CIRCUIT COMPARISON

ChryslerScanner

Original schematic -> current circuit sets

Original: Daniel Laszlo, revision 2.4.0-1, 2026-01-05. Current: Rev C, 24 pages / 329 circuit-probe endpoints.

01 Vehicle battery input

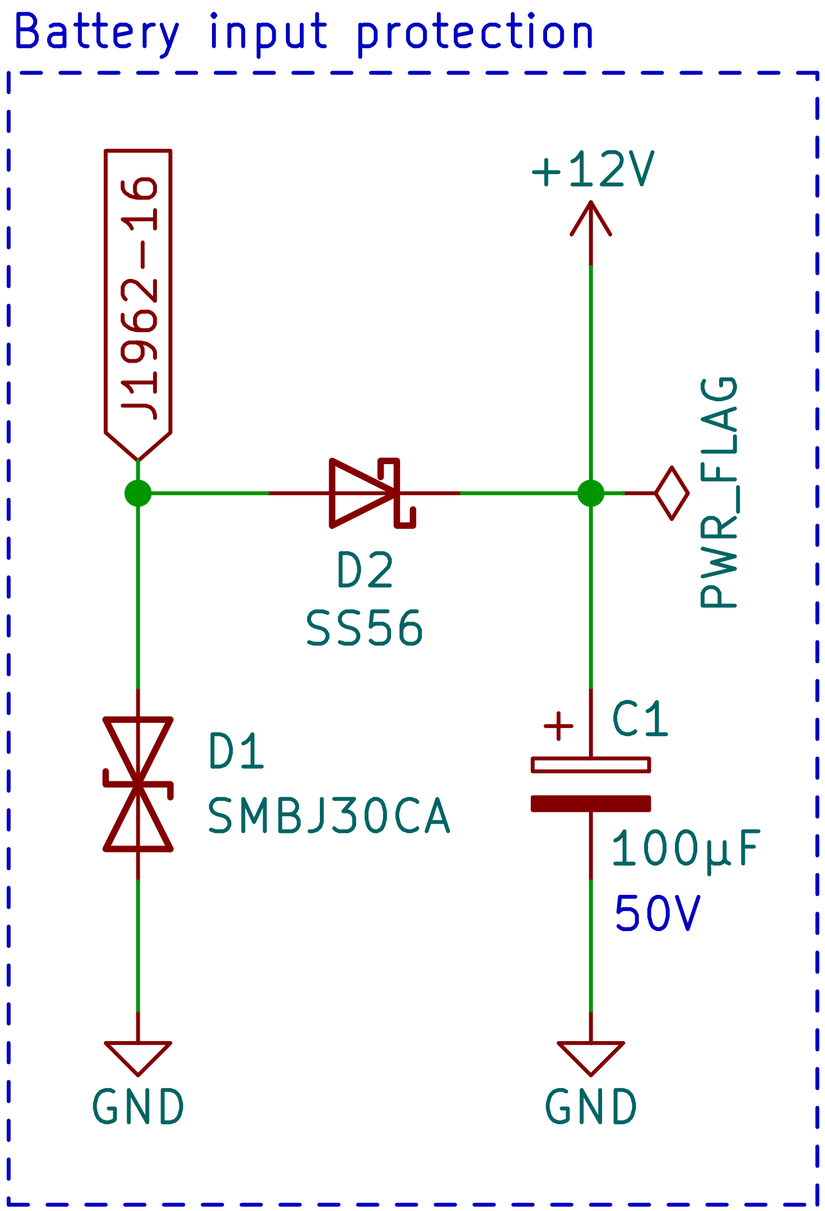
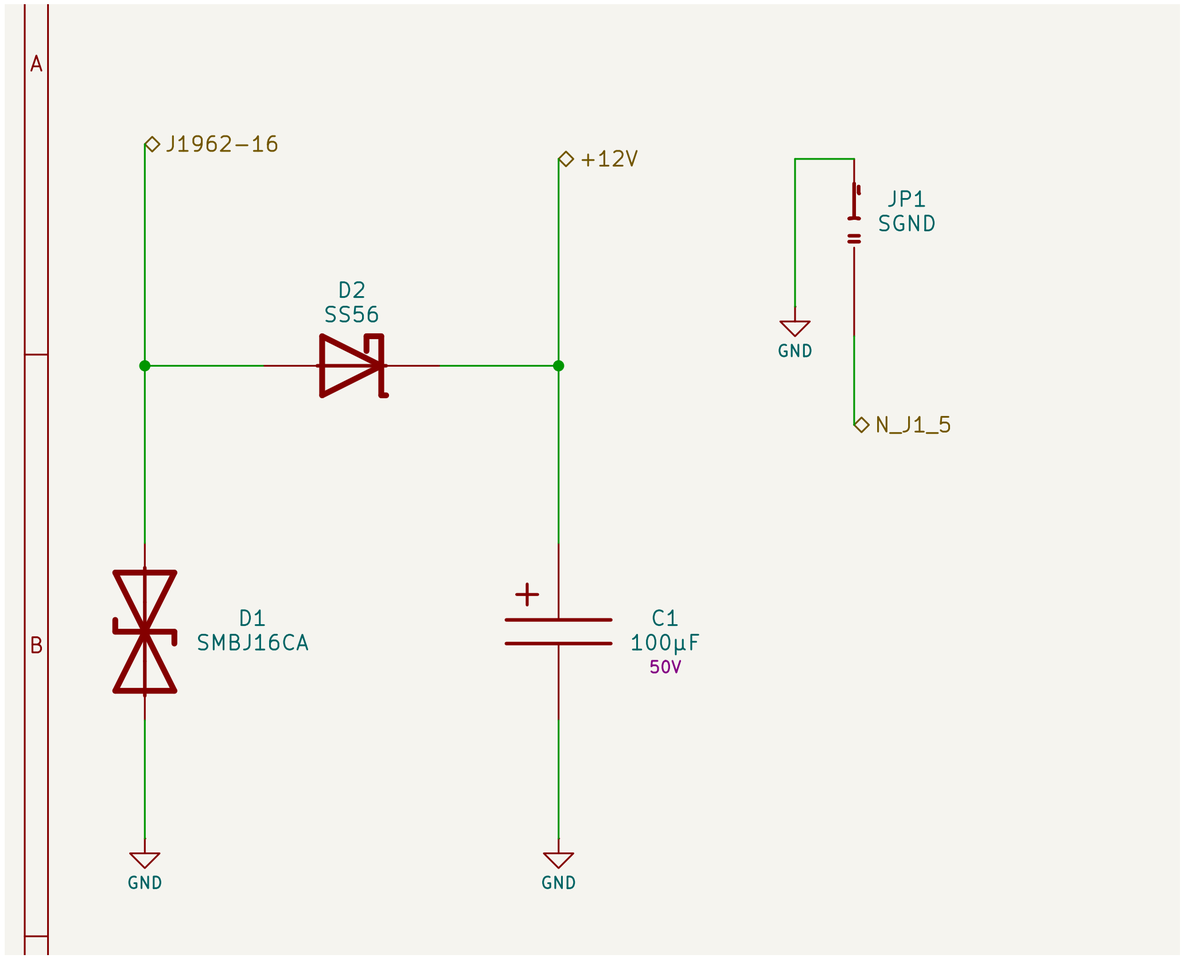
- D1 changes from SMBJ30CA to SMBJ16CA. D2, C1 and the JP1 signal-ground link remain.
- The battery ADC now senses protected +12V after D2, rather than raw J1962-16. This is an intentional safety change.

02 OBD connector and line protection

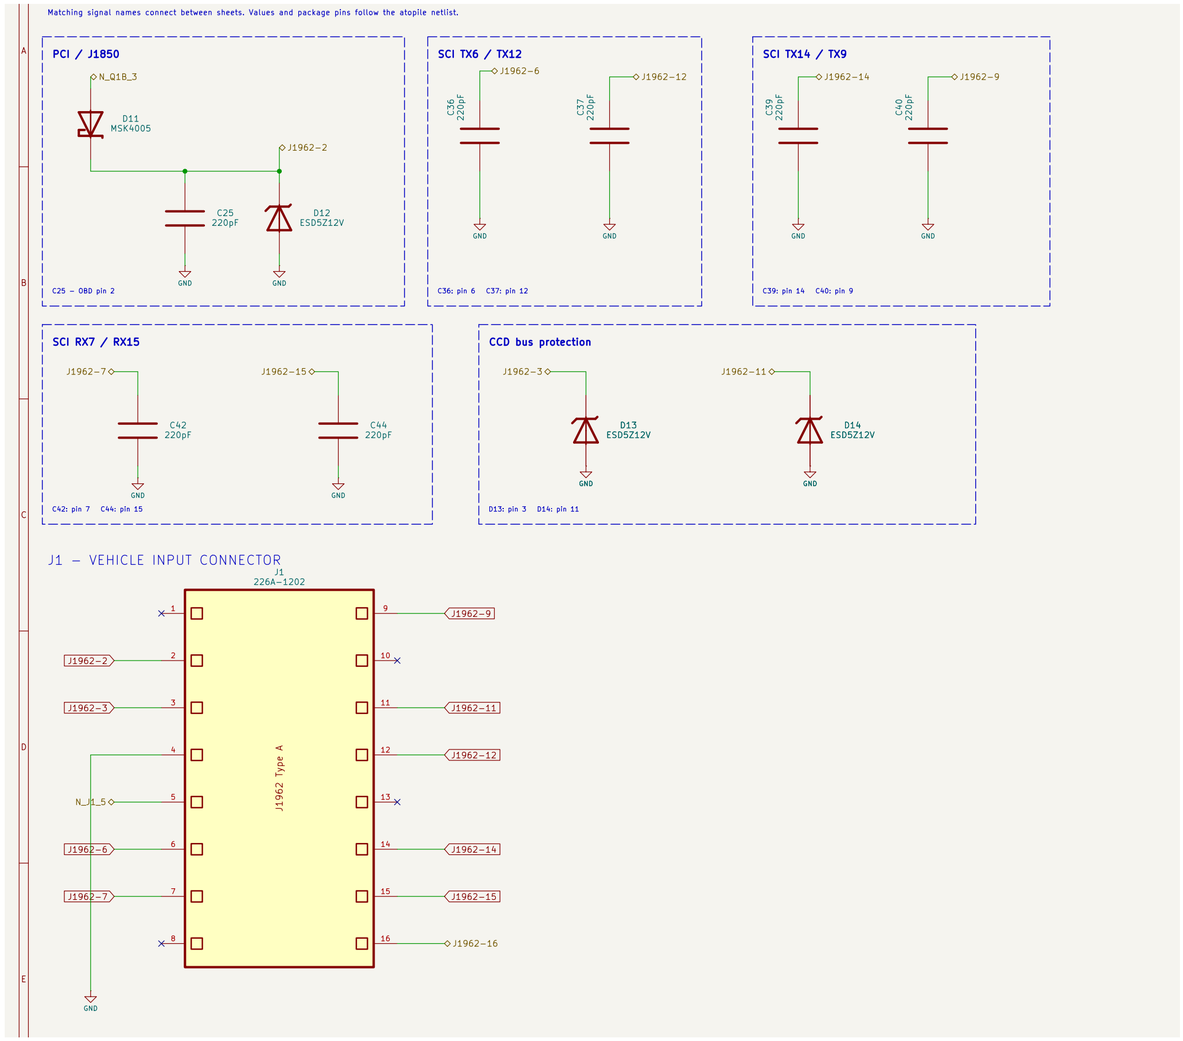
- J1 is now an ATTEND 226A-1202; logical vehicle pin assignments are retained.
- Capacitors and protection diodes formerly scattered across bus blocks are grouped by PCI, SCI and CCD on one page. These crops identify their original locations.

03 USB connector and power selection

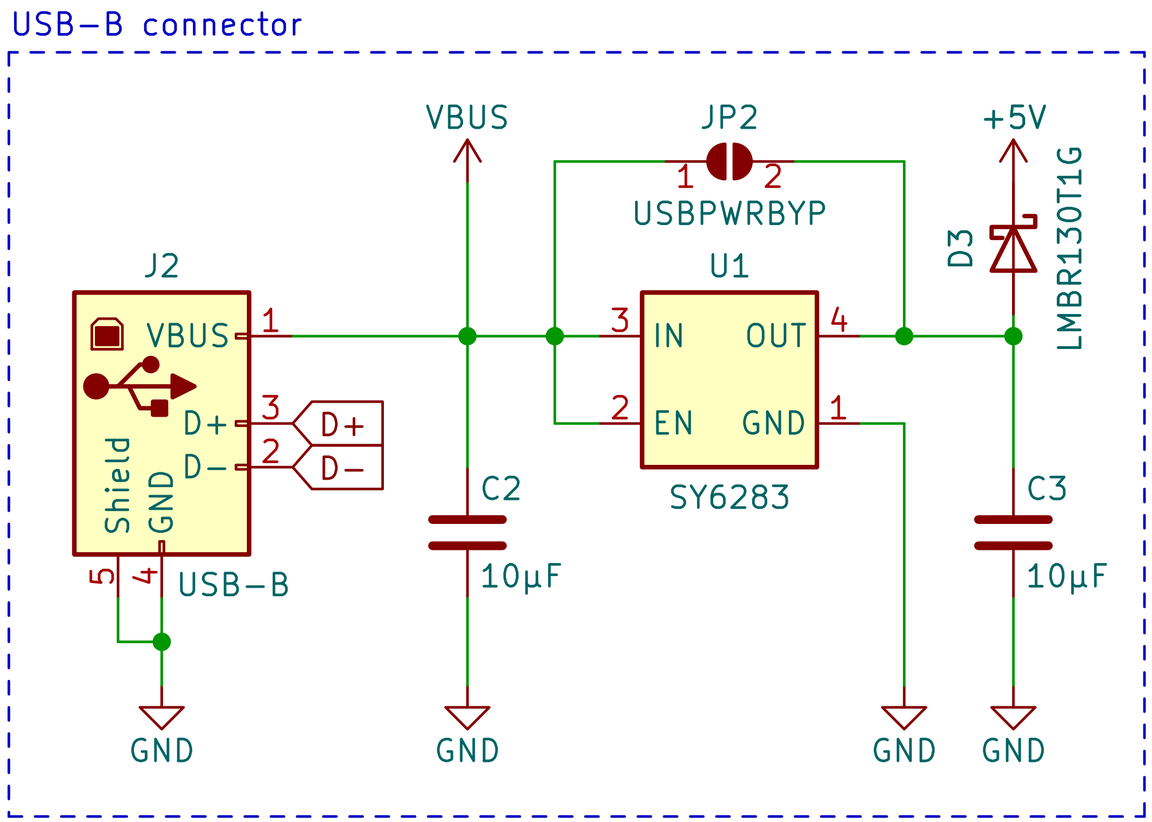
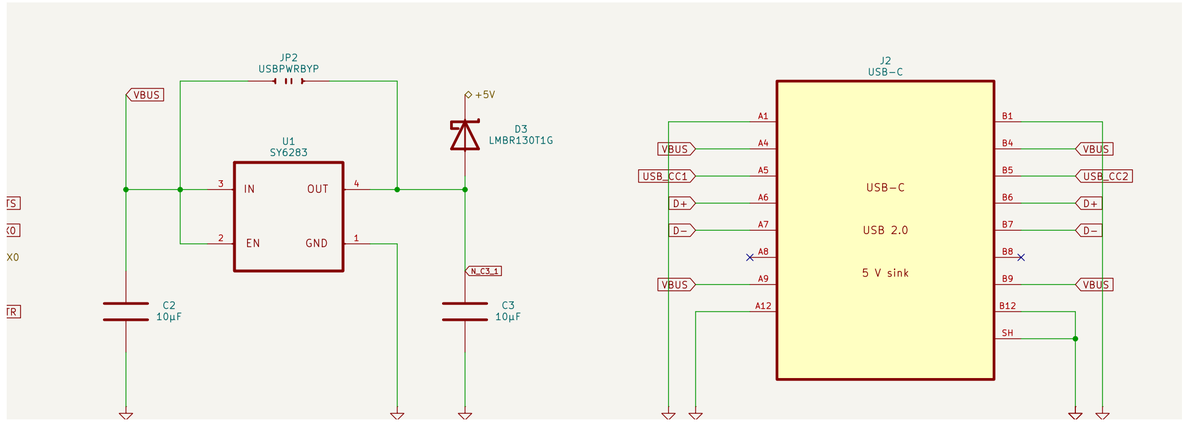
- USB-B is deliberately replaced by USB-C, with separate CC pull-down resistors R102/R103.
- U1 SY6283 power switching, JP2 bypass, D3 and the input/output capacitor functions remain. See comparison 11 for UART/ESD circuitry.

06 VPP programming boost supply

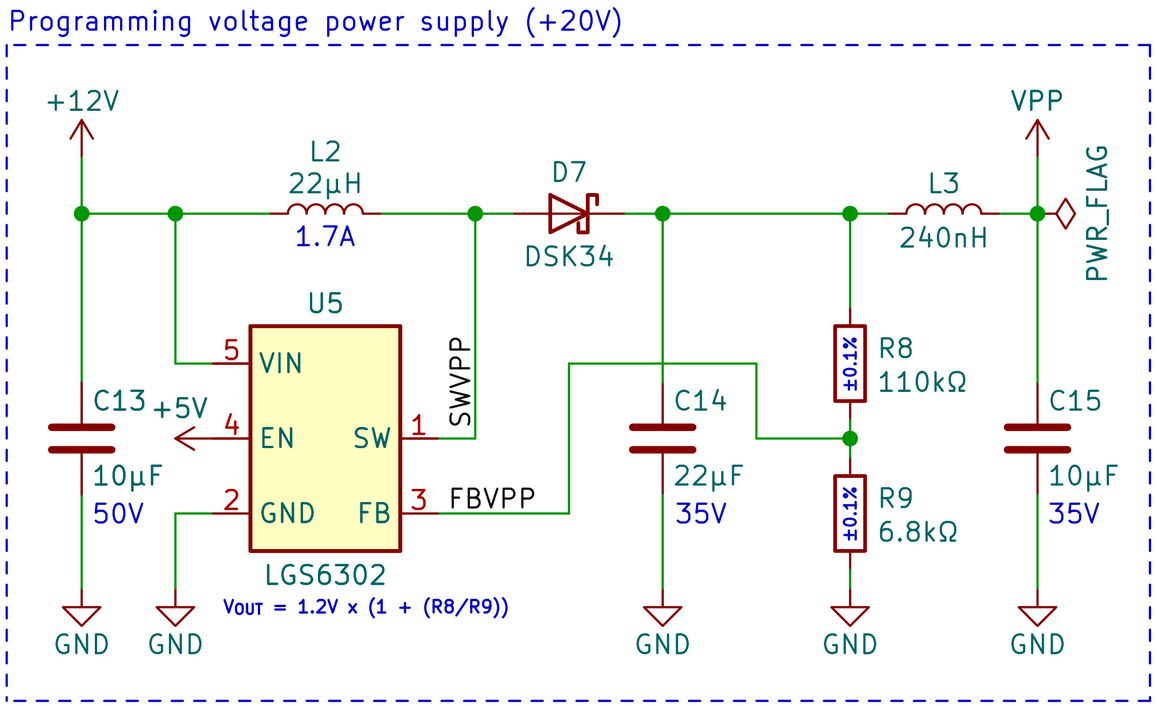
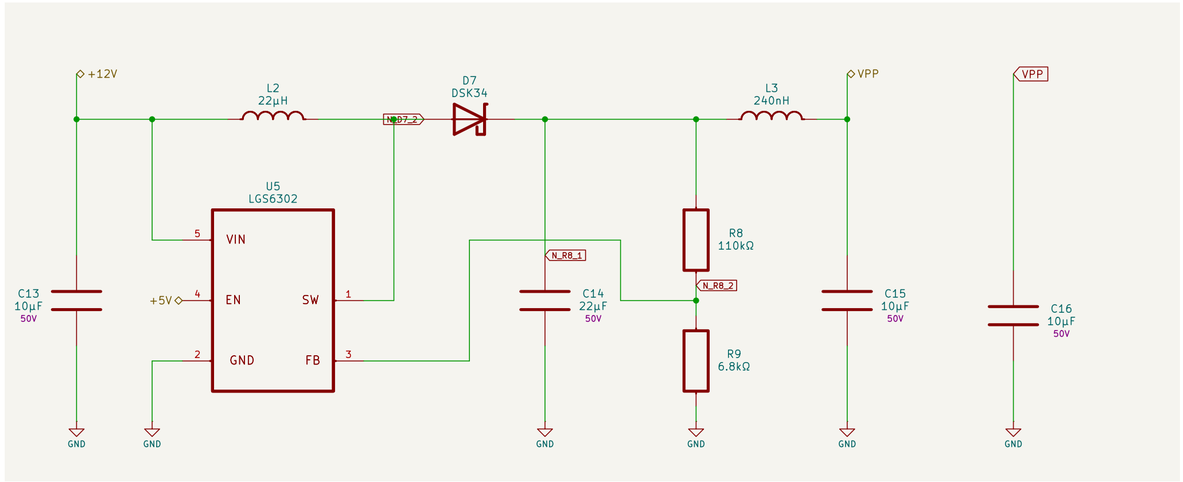
- The original boost topology and programming-rail function remain.
- C14 and C15 now specify at least 50 V, deliberately increased from the original 35 V labels. The bounded prototype still requires protected-input/VPP peaks at or below 28 V.

09 PCI / J1850 receiver and transmitter

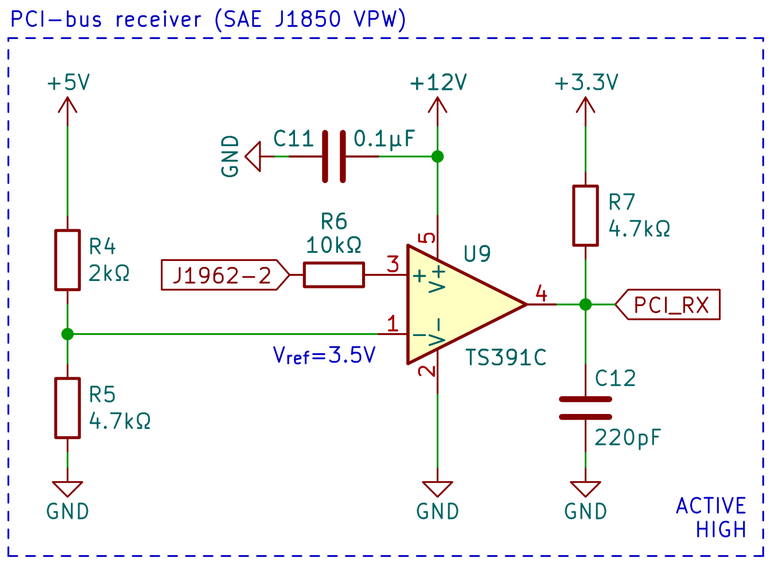
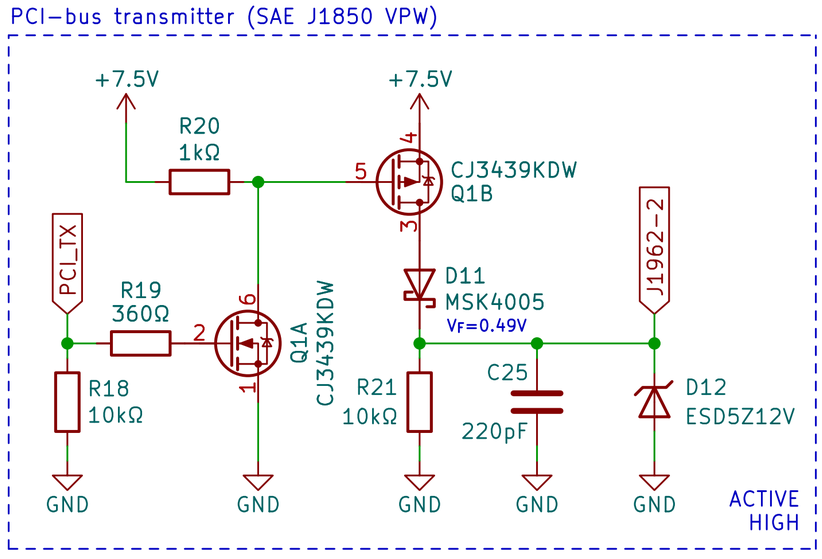
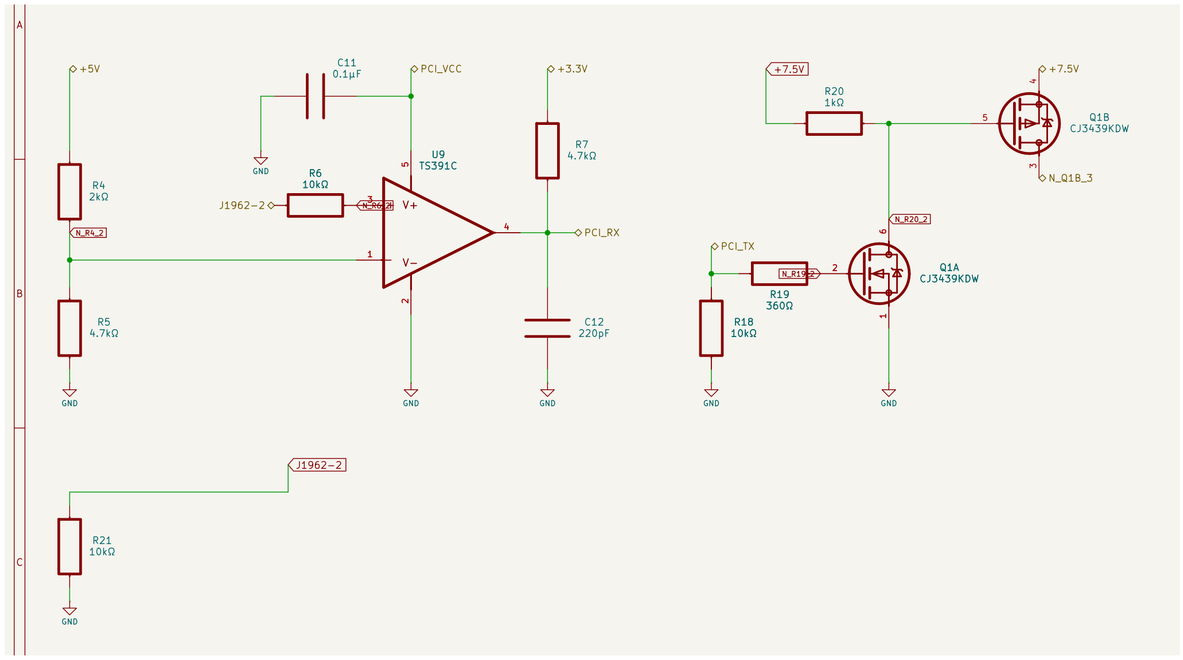
- U9, Q1, R4-R7 and R18-R21 retain the PCI receive/transmit functions.
- U9.5 and C11.2 now use the separately clamped PCI_VCC rail instead of direct +12V. C25 and D11/D12 are displayed on the connector/protection page.

10 ESP32, RF and local decoupling

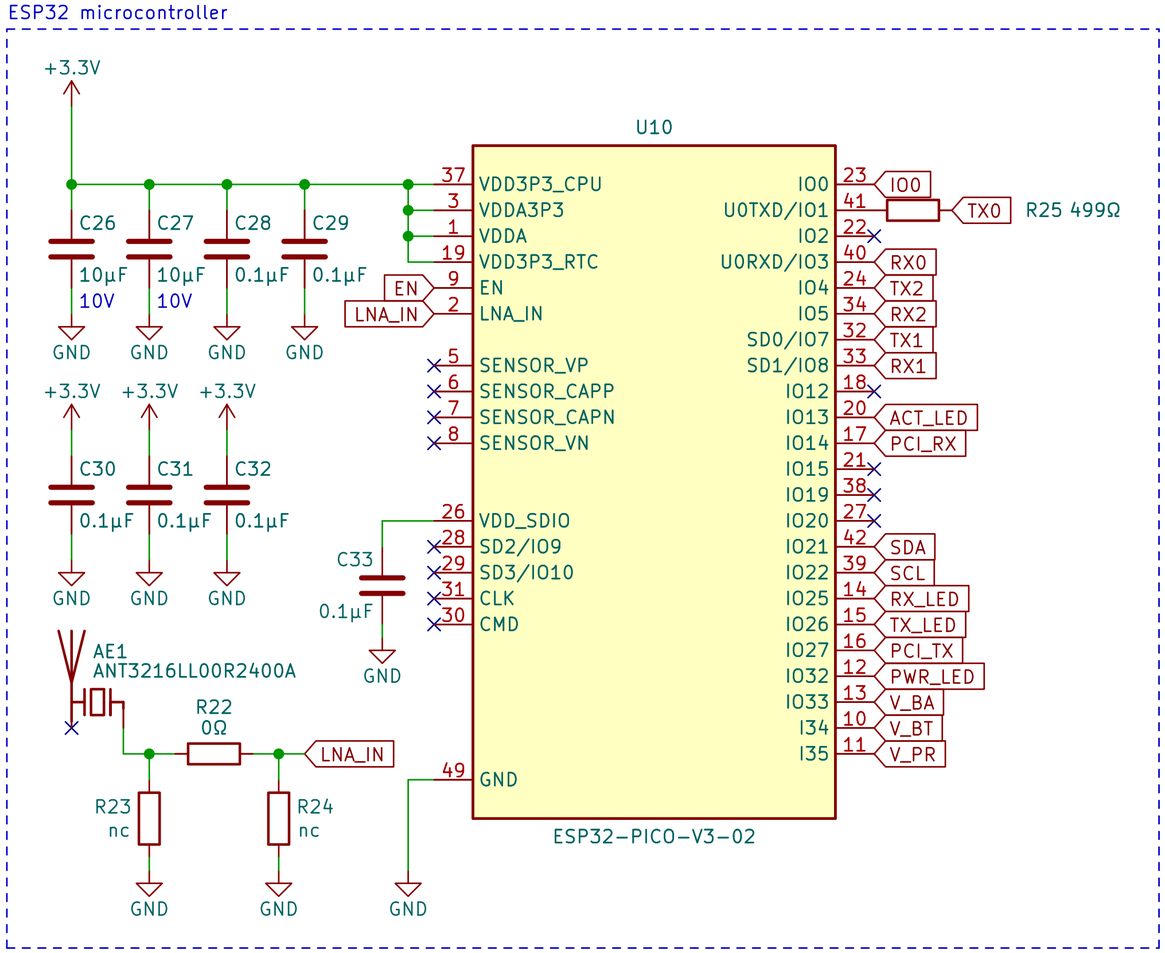
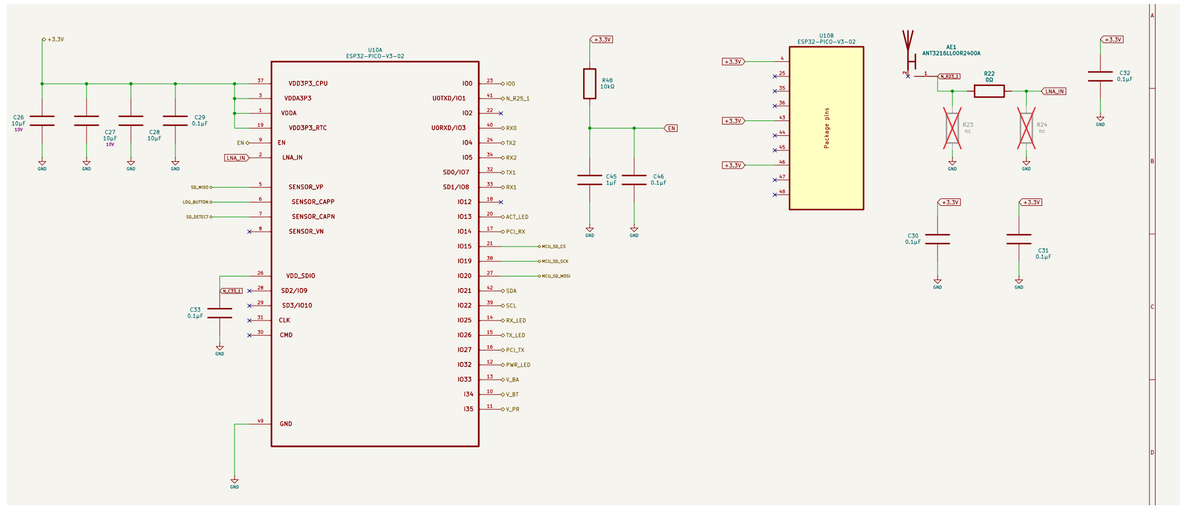
- The original ESP32 package, RF network and existing functional pin assignments remain.
- Previously unused U10 pads 5, 6, 7, 21, 27 and 38 now serve SD and logging functions. ACT_LED is assigned exclusively to the supervised health heartbeat; legacy activity firmware is incompatible.

11 USB / UART bridge and USB ESD

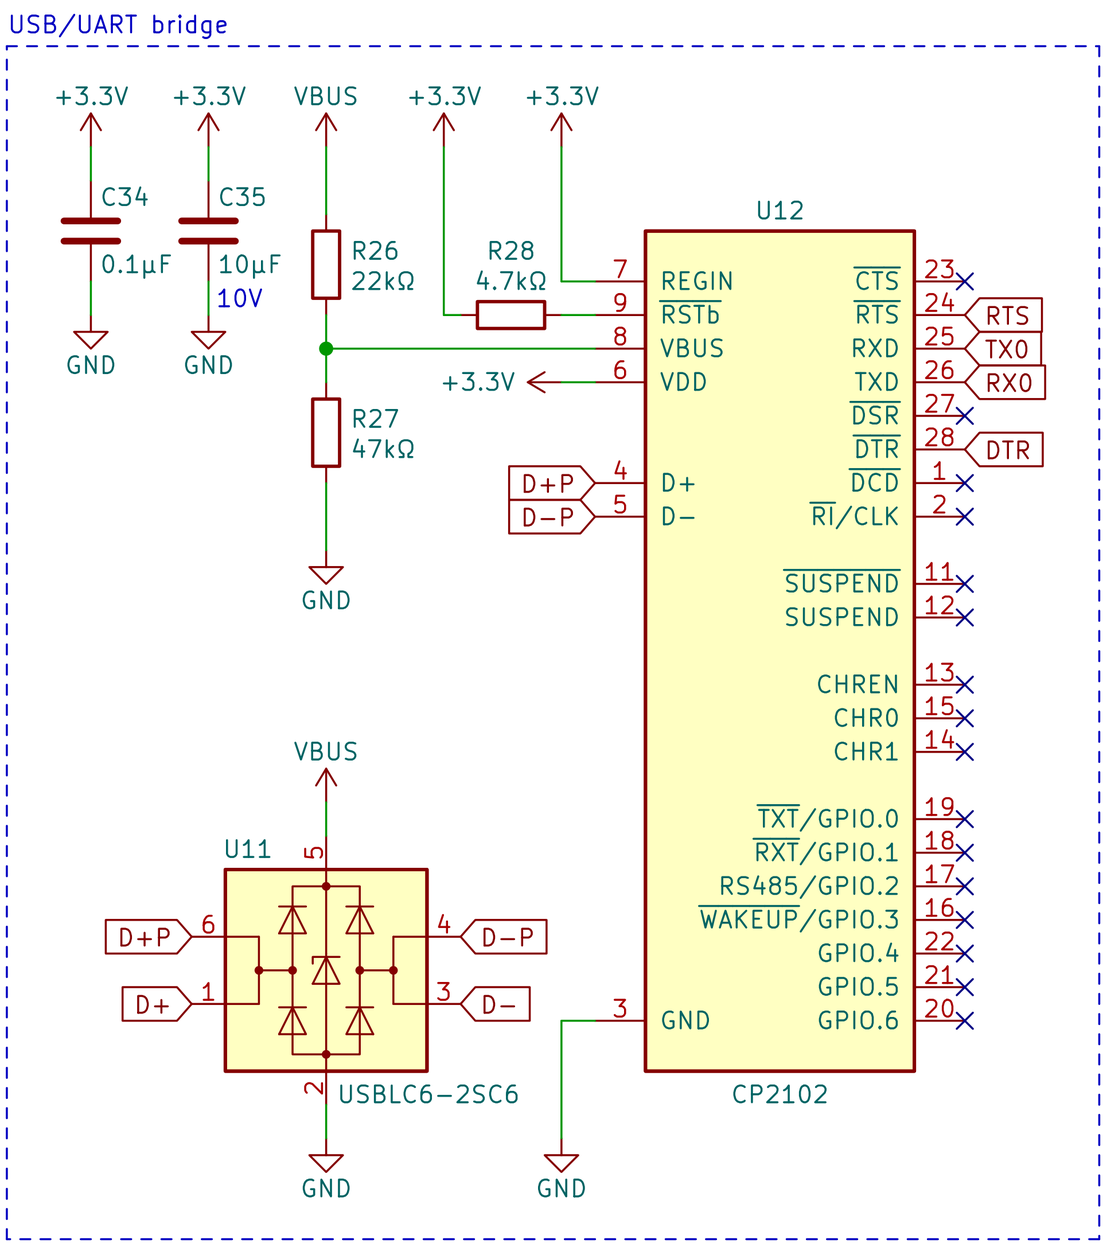
- The classic CP2102 is retained; this is not a CP2102N conversion. U11 retains the USBLC6 protection function.
- The current symbol drawing is split into several units belonging to U12. USB-C contact mapping and CC termination are intentional additions.
